**EB-2022-0335 – Enbridge IRP Pilot Projects  
Pollution Probe Interrogatories to the Applicant**

**Enbridge Gas Inc.  
IRP Pilot Projects**

**POLLUTION PROBE INTERROGATORIES**

Figure 15: Comparison between energy savings achieved by all-electric CC-ASHP and gas-hybrid in Archetype B (Post 1980s 2-story home), relative to a gas-furnace

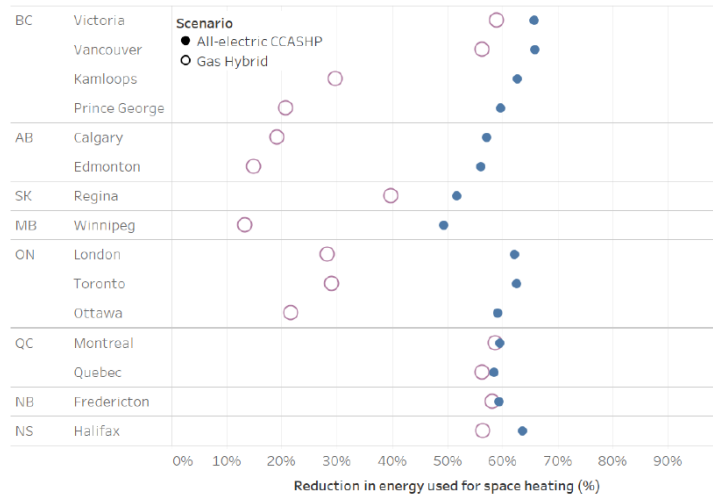
The above-noted CanmetENERGY report indicates that Hybrid Heating systems are less efficient than an all electric ccASHP system. If Enbridge has any reports or information which suggests otherwise, please provide a copy.
